SLOVENSKI STANDARD SIST EN 15254-4:2008/kFprA1:2011

Extended application of test results from fire resistance tests - Non-loadbearing walls - Part 4: Glazed constructions

<u>SIST EN 15254-4:2008/kFprA1:2011</u> https://standards.iteh.ai/catalog/standards/sist/7eb3e9a4-fdb1-4ec7-bee5-8528767e3734/sist-en-15254-4-2008-kfpra1-2011 EUROPEAN STANDARD NORME EUROPÉENNE EUROPÄISCHE NORM FINAL DRAFT EN 15254-4:2008

This draft amendment A1, if approved, will modify the European Standard EN 15254-4:2008. If this draft becomes an amendment, CEN members are bound to comply with the CEN/CENELEC Internal Regulations which stipulate the conditions for inclusion of this amendment into the relevant national standard without any alteration.

4 Modification to Figure B.1

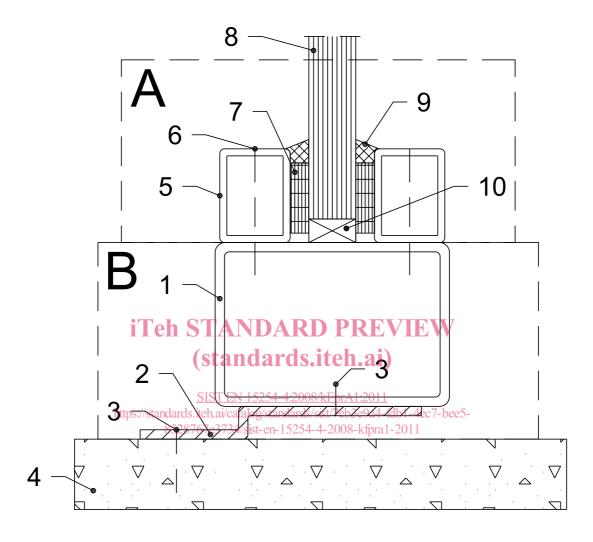
Replace the figure and key with the following: "

Key

- A glazing system
- B framing system

Framing system consisting of:

- 1 frame
- 2 metal anchor, screwed or bolted to the wall 4 by a fixing anchor 3
- 3 screw and fixing anchor
- 4 wall
- 5 bead, screwed or clipped
- 6 bead fixing
- 7 glazing strip
- 8 glass
- 9 sealing of gasket
- 10 setting block
